**BOARD OF PUBLIC WORKS AND SAFETY  
Agenda Request Form**

RE: Franklin Greenways Trail Amphitheater  
Change Order #1

RE: Franklin Greenways Trail Amphitheater  
Change Order #2

RE: Franklin Greenways Trail Amphitheater  
Change Order #3

TIMBER RAILING DETAIL - ABUTMENT NO. 2 LAYOUT

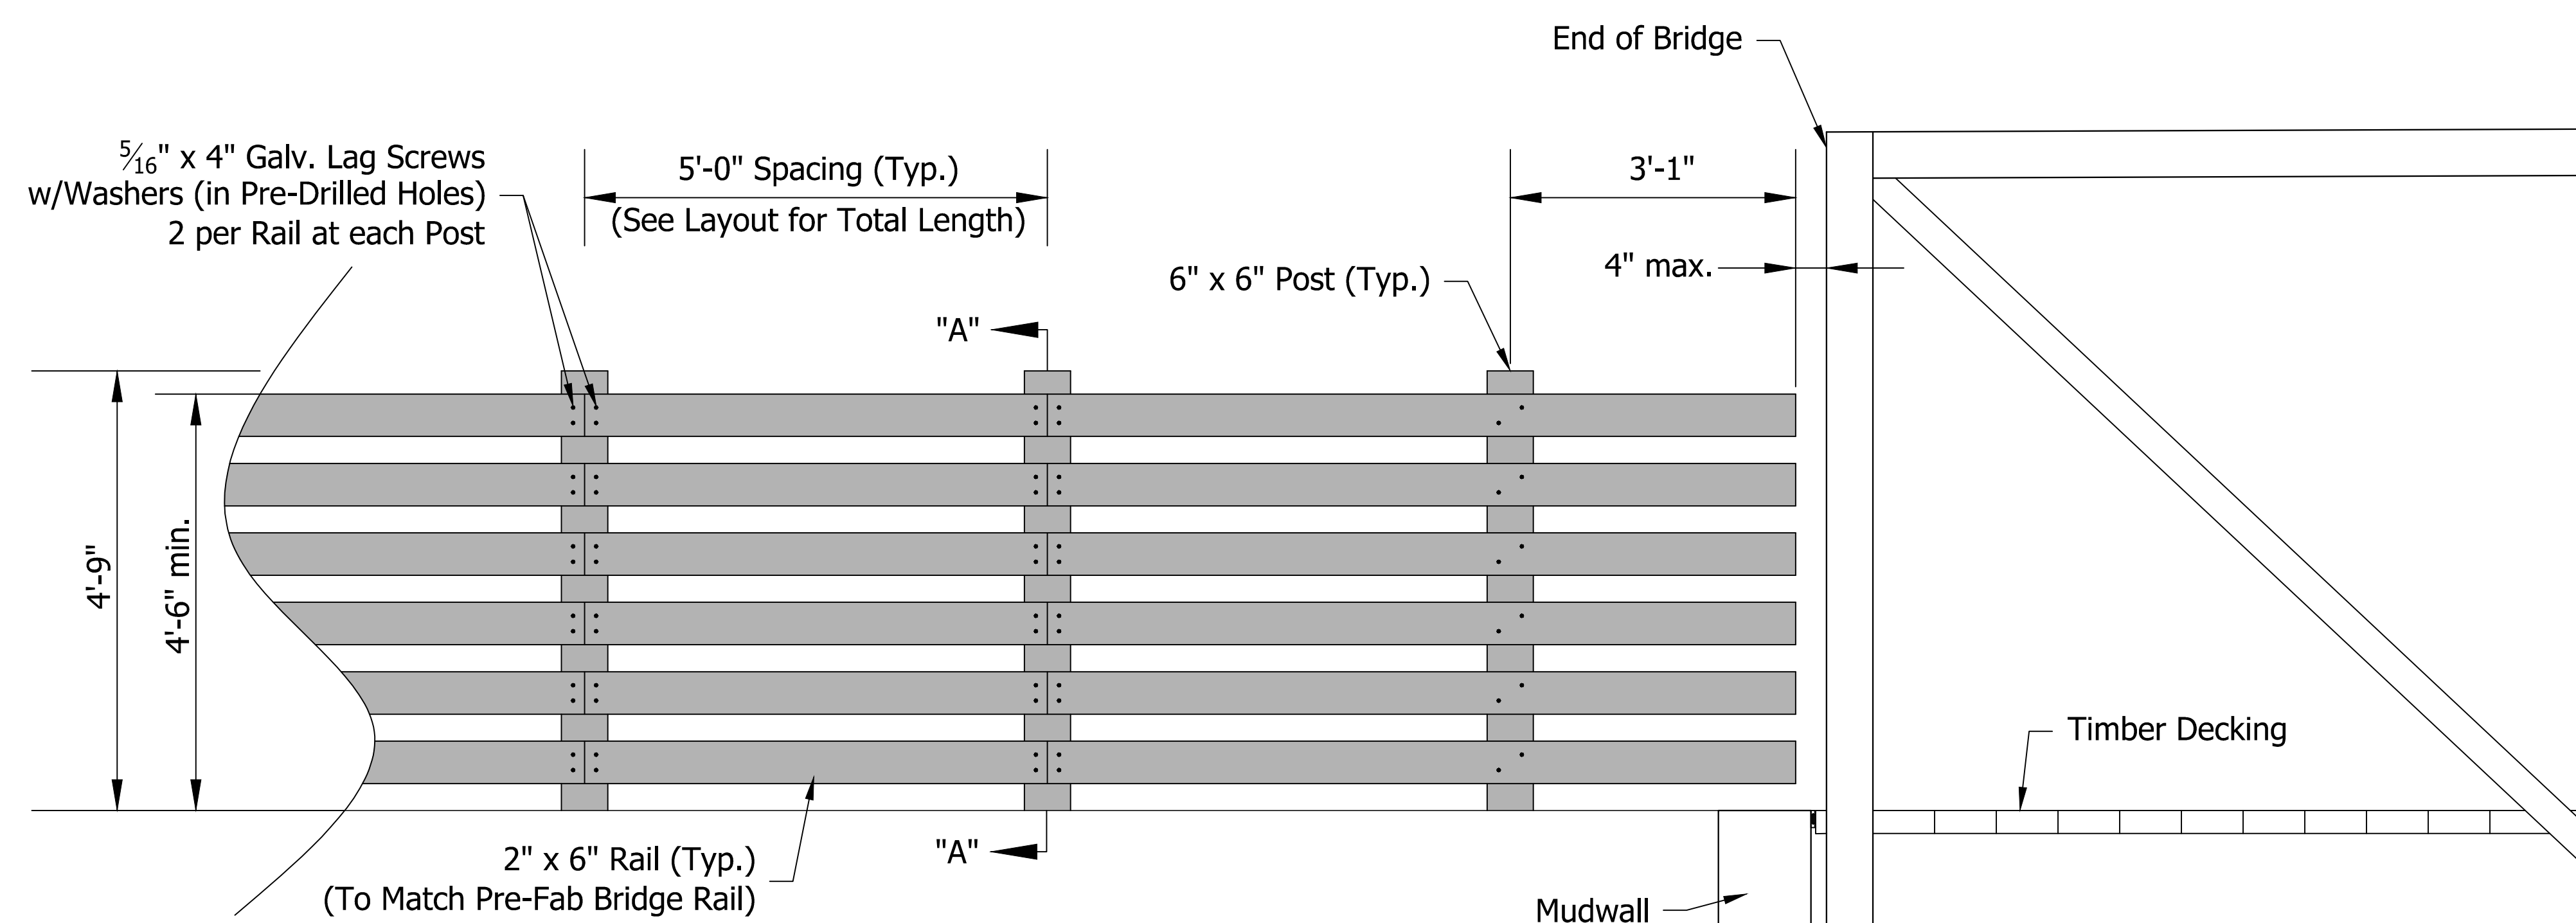
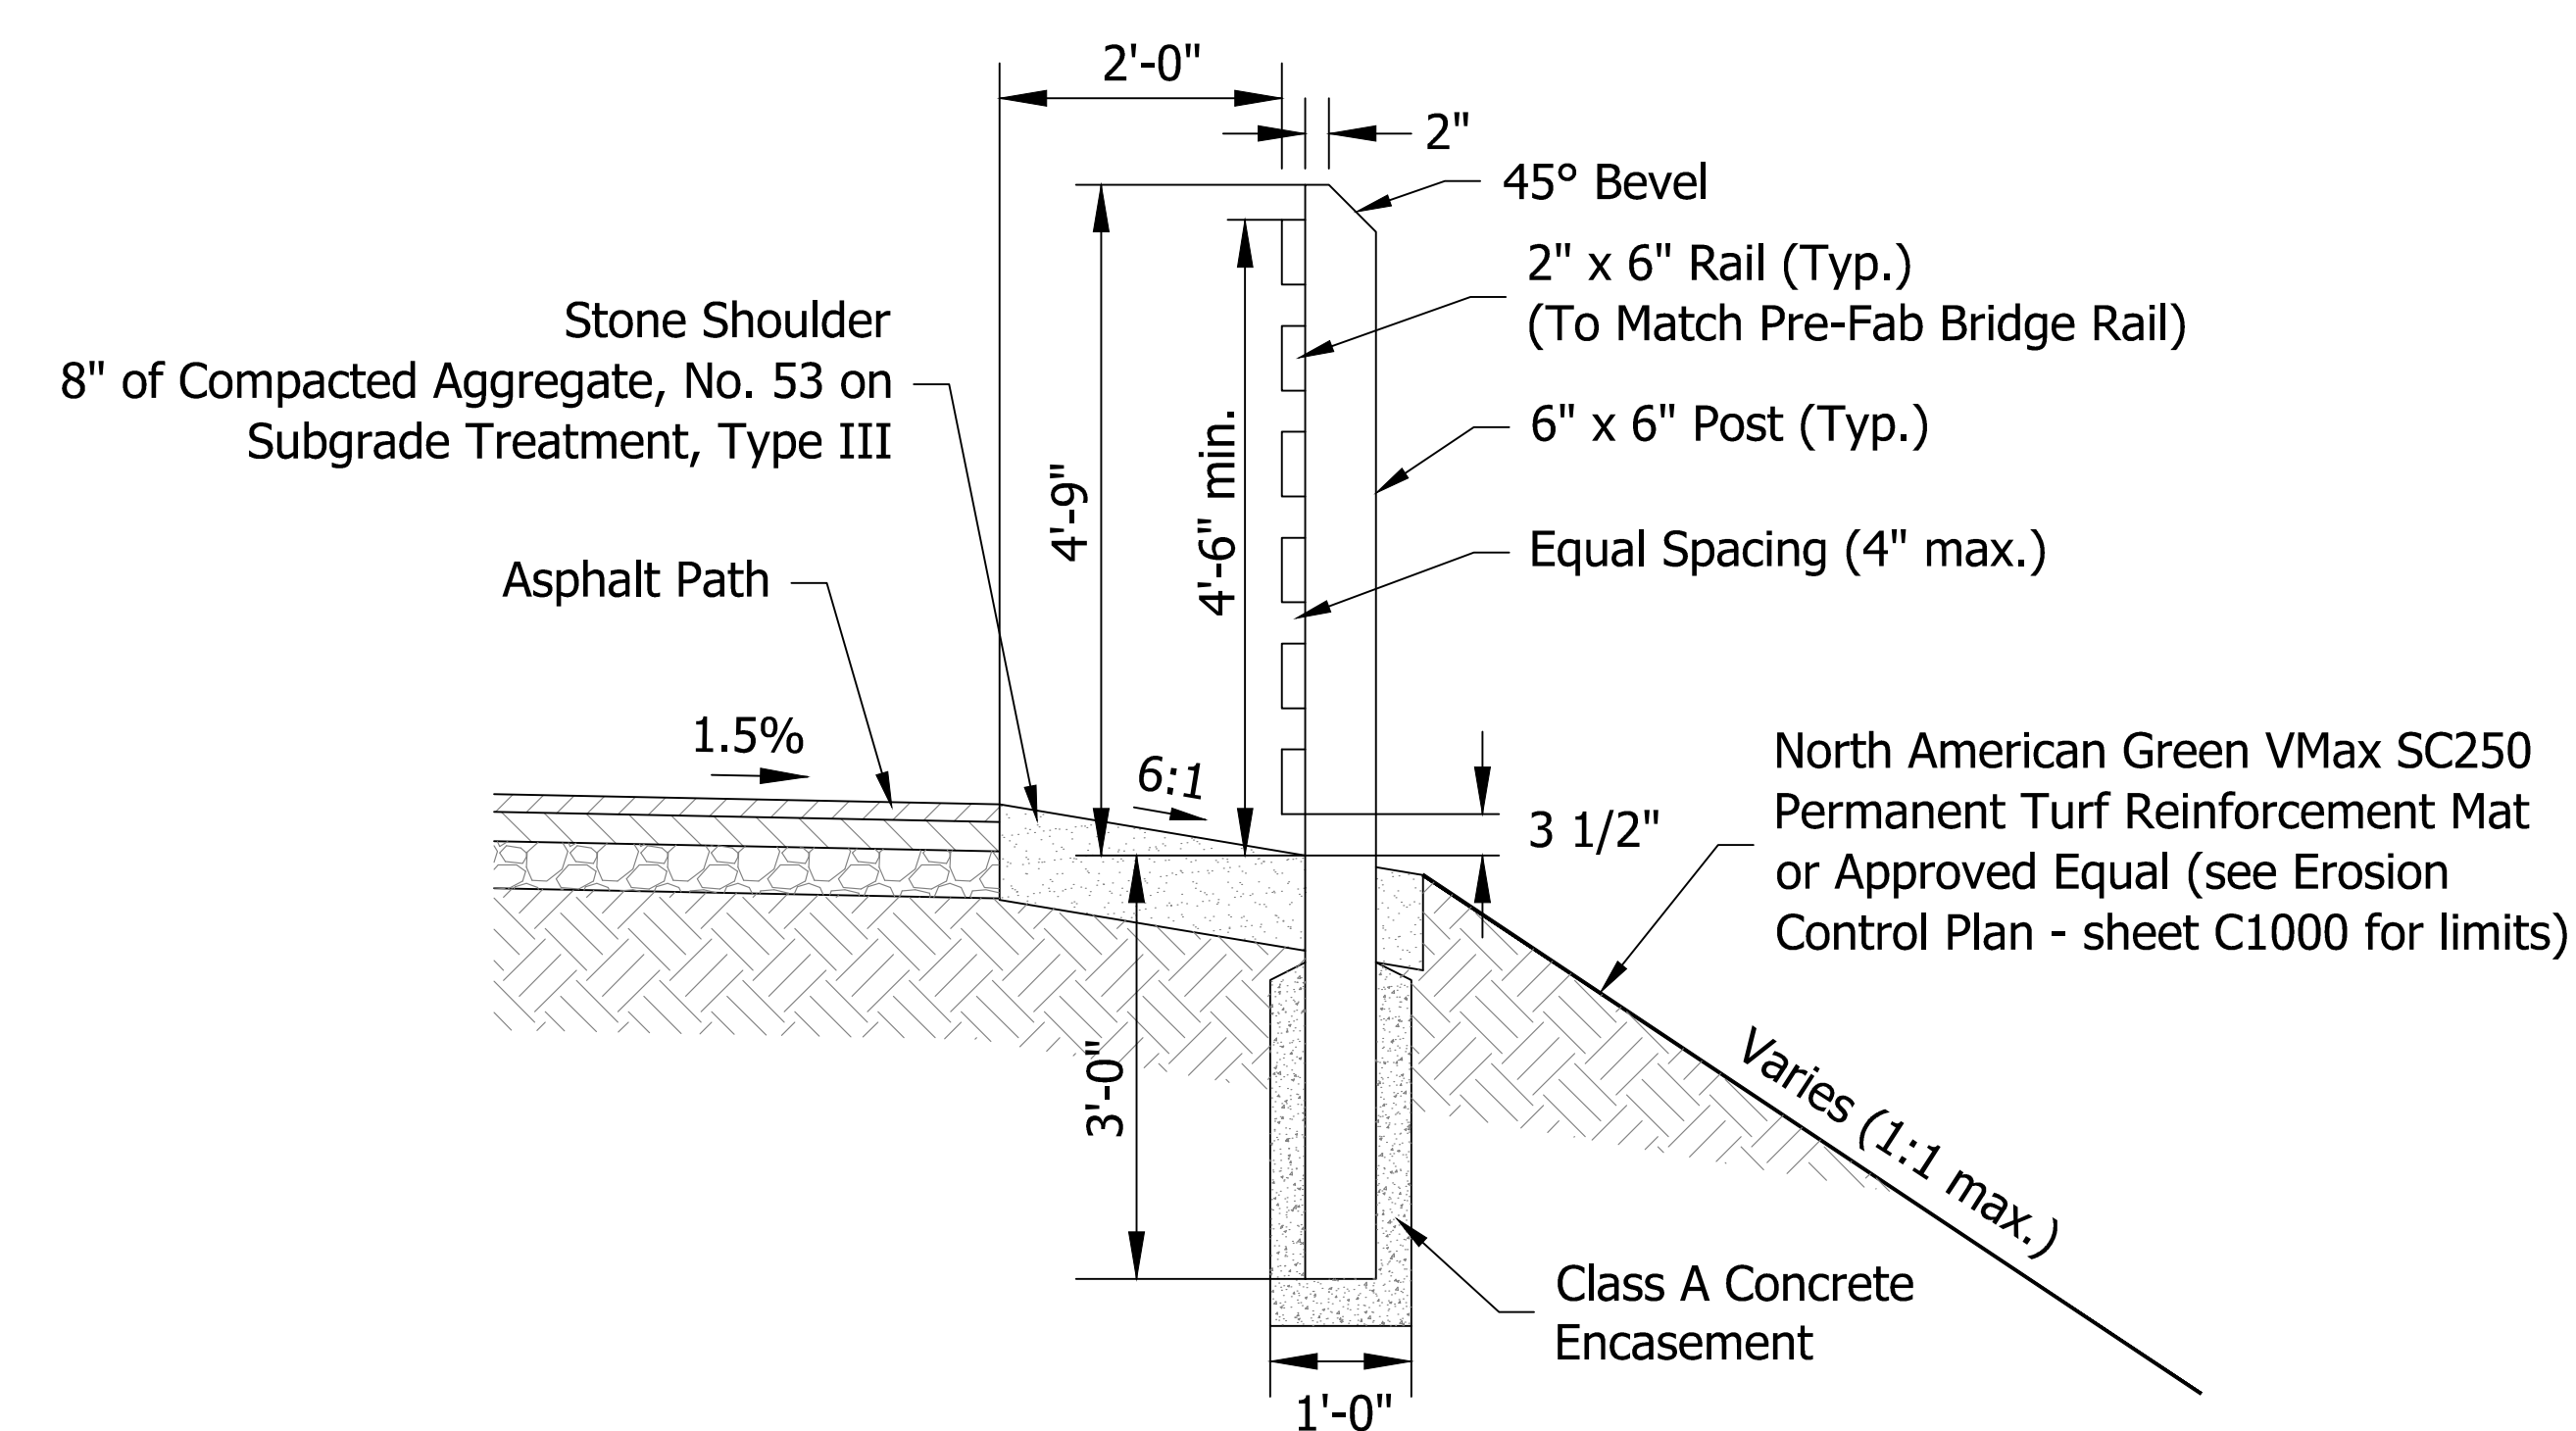
After reevaluating the side slopes on all four (4) corners where the HMA path ties into the pedestrian bridge deck, CrossRoad Engineers has determined that a timber safety railing needs to be installed on all corners. A three-foot-wide compacted stone shoulder will also need to be installed along the trail in these areas.

Please see the railing detail attached in this price request and provide a unit price to complete the installation of the railing and the compacted aggregate shoulders. Pricing shall be provided on a per linear foot basis for the railing and a per ton basis for the aggregate and in accordance with INDOT standard specification 109.05(a). The work shall be completed in accordance with the attached standard specifications.

The timber railing end treatments shall be located at all corners of the bridge. The top rail of the end treatment shall have a top rail height that matches the top of the second rail on the bridge railing, between 42 and 45 in. The spacing of the remaining rails shall match the spacing used on the timber bridge railing. A 4 in. gap shall be provided between the end of the truss railing and the beginning of the end treatment.

Timber posts shall be spaced as shown in the contract plan sheet (C1200). The posts shall be placed in holes measuring 12 in. in diameter and 42 in. deep. The bottom of the post shall be located 36 inches below the finished ground elevation. Posts shall be aligned parallel to the path and braced in a vertical position. Concrete shall be placed around the post to within 6 in. of the finished ground elevation.

The rails shall be attached to the post using two 5/16 in. by 4 in. galvanized lag screws with galvanized washers per rail per post. Holes shall be pre-drilled and countersunk the total depth of the lag screw head and washer, providing a flush finished surface with no protrusions. 3' wide compacted aggregate shoulders shall be constructed as shown in the plans.

DATE: <b>2020.05.08</b>	PROJECT NO.: <b>19-0107</b>
DRAWN BY: <b>RDG</b>	CHECKED BY: <b>MAM</b>
DRAWING STATUS:	
<b>FINAL CONSTRUCTION DRAWINGS</b>	
SHEET TITLE:	
<b>PEDESTRIAN BRIDGE ABUTMENT DETAILS</b>	
SHEET NO.:	
<b>C901</b>

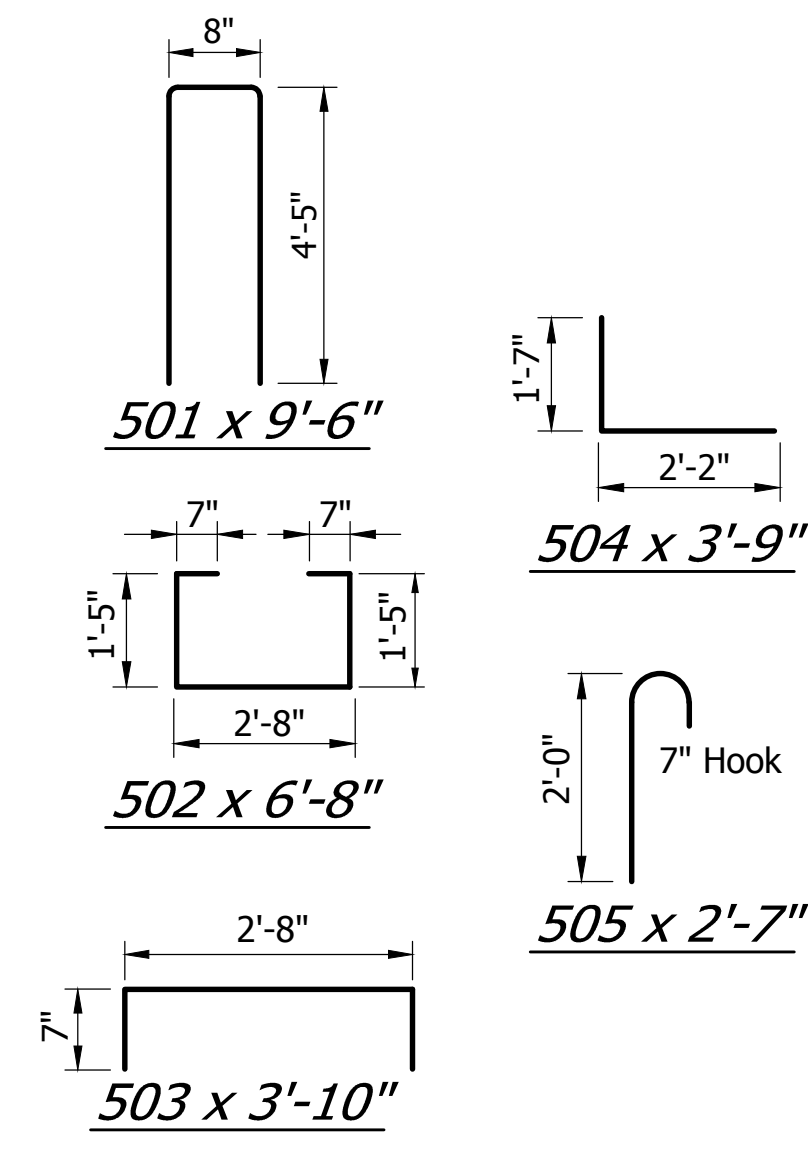
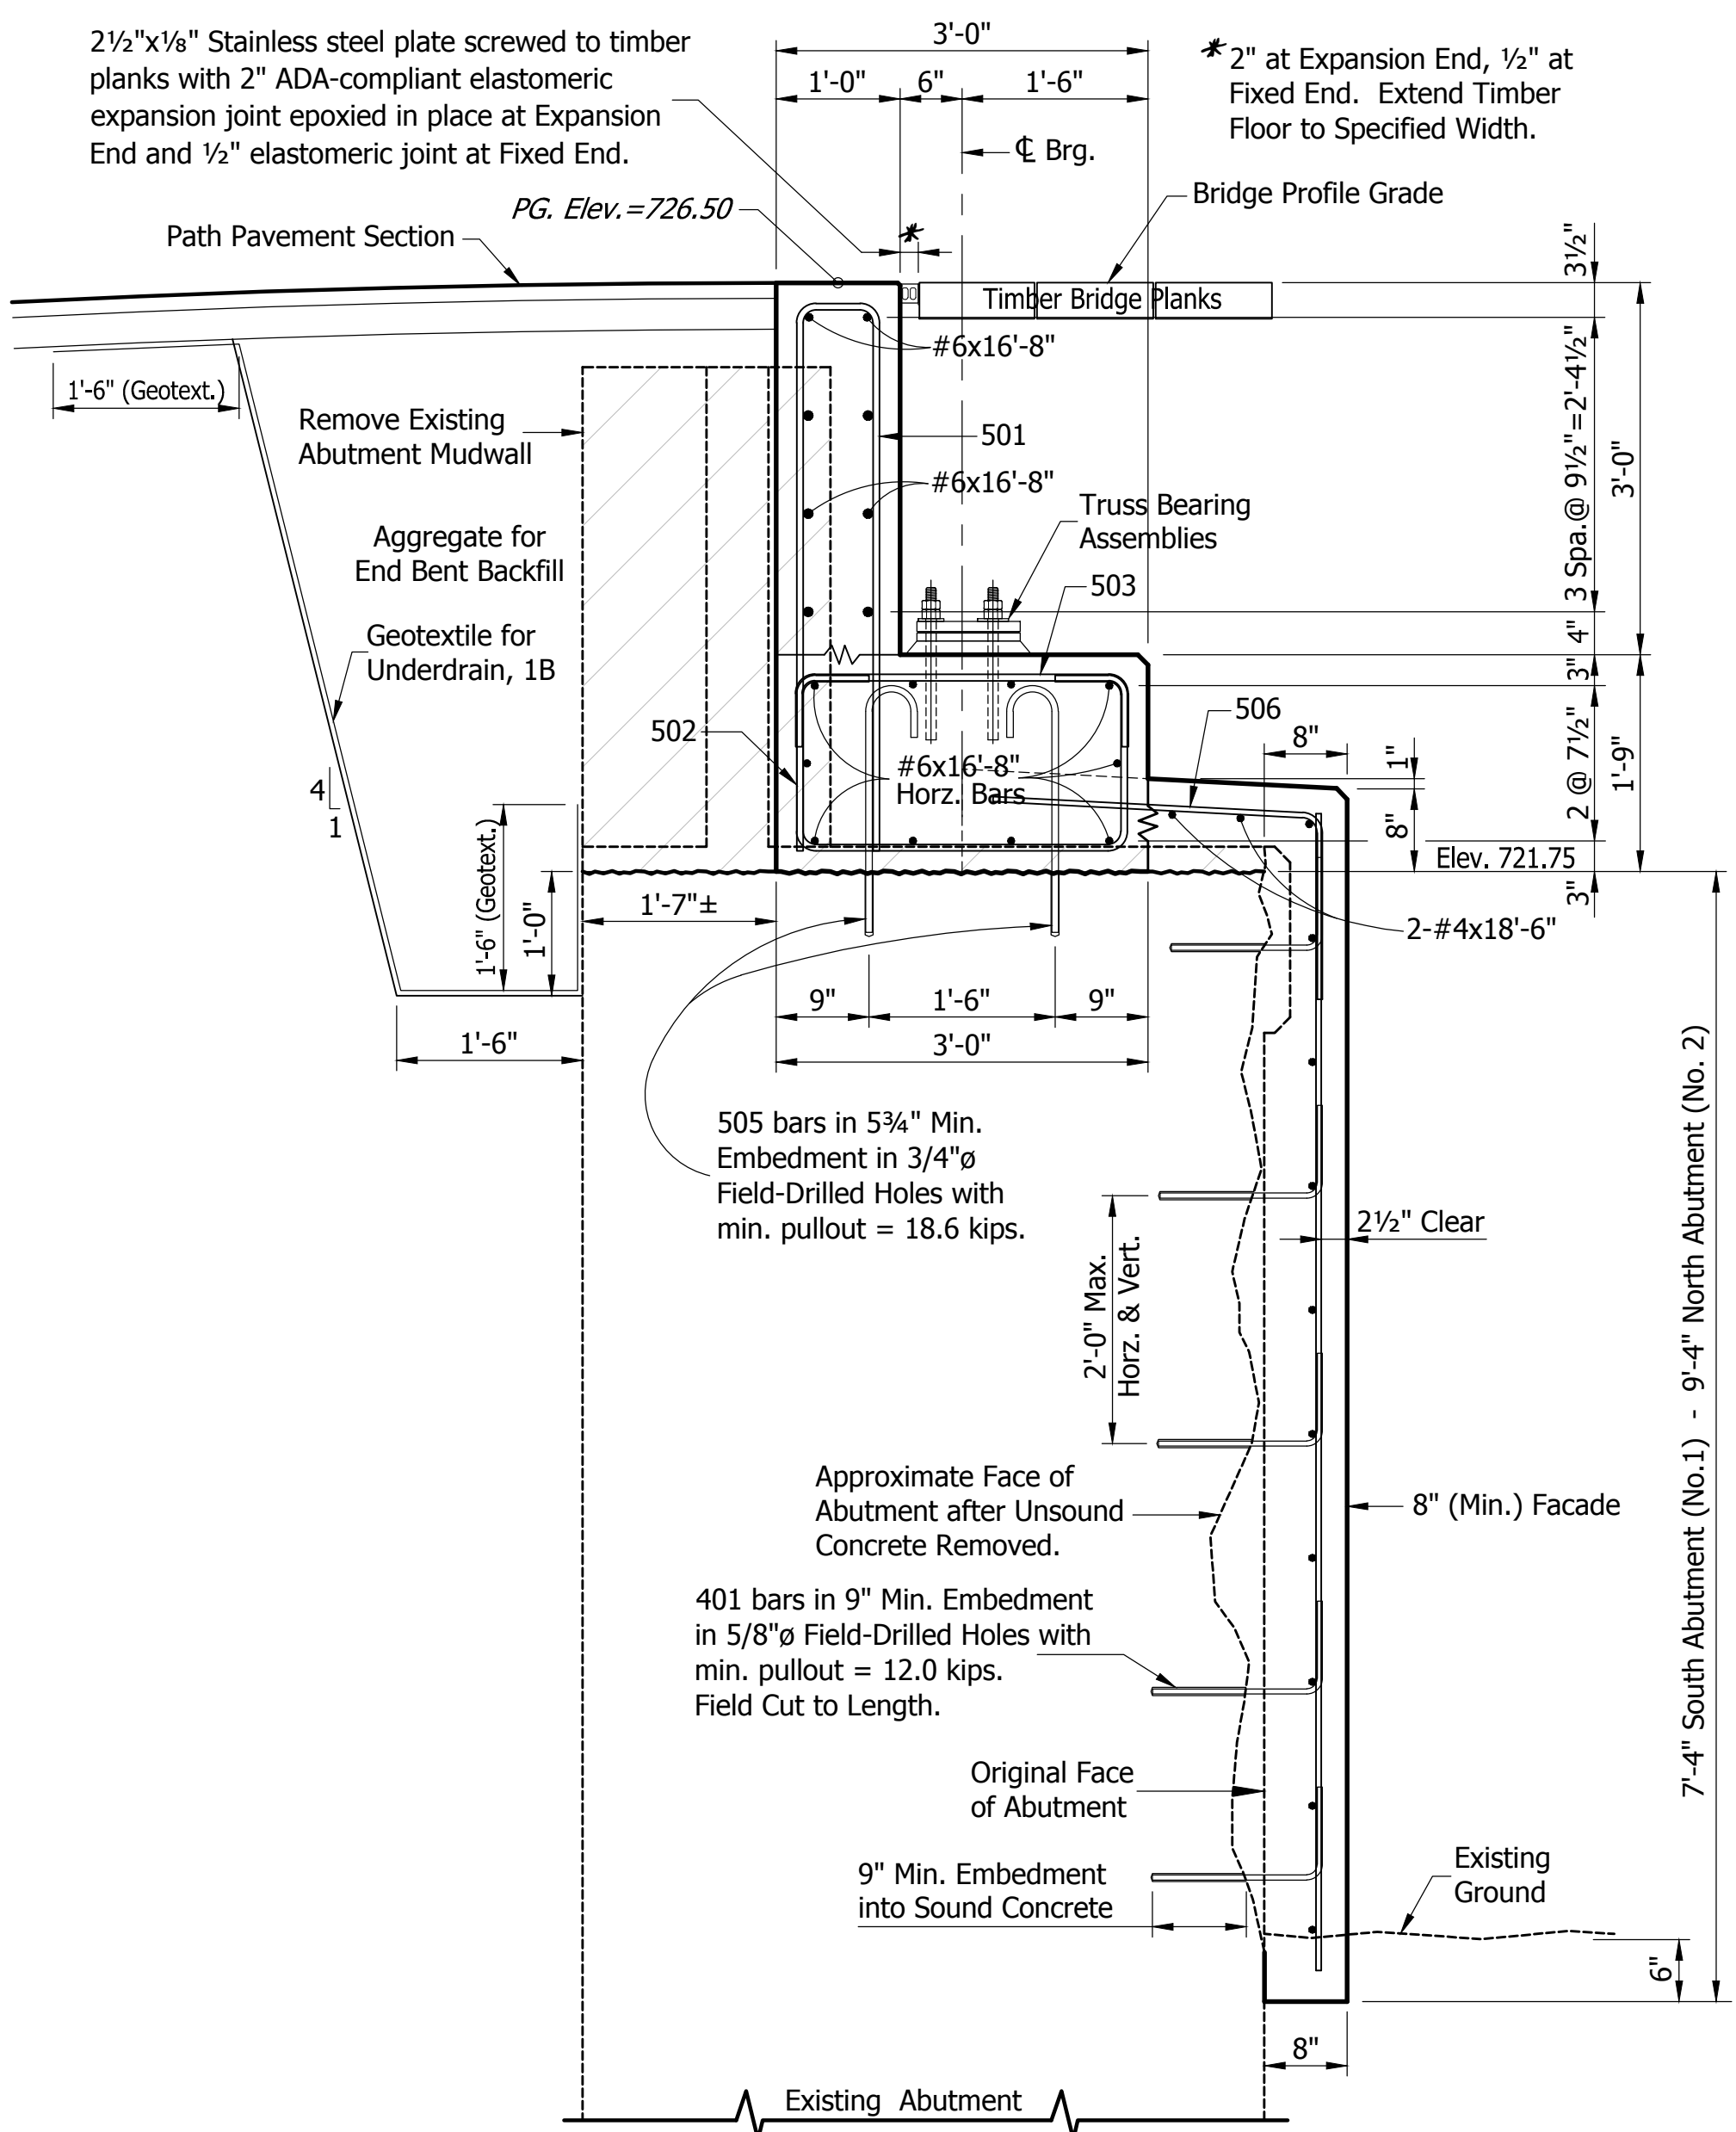
The existing bridge abutments that the pedestrian bridge will be set on will require some concrete patching. There will be removal of unsound concrete on the face of both the north and south abutments and an 8" concrete façade will be poured and tied into the existing abutments with doweled steel.

After checking the existing bridge abutments that the pedestrian bridge is to be set on, Crossroad Engineers have determined that there needs to be some structural concrete patching completed. Both the north and south abutments will require concrete patching.

Please provide a unit price to complete the structural patching on the abutments for the quantity below. Pricing shall be provided on a square foot basis. Pricing shall be provided in accordance with INDOT standard specification 109.05(a) and the work shall be completed in accordance with INDOT standard spec section 710.

ITEM CODE	DESCRIPTION	QTY	UNIT
710-09158	Patching Concrete Structures	380	SFT
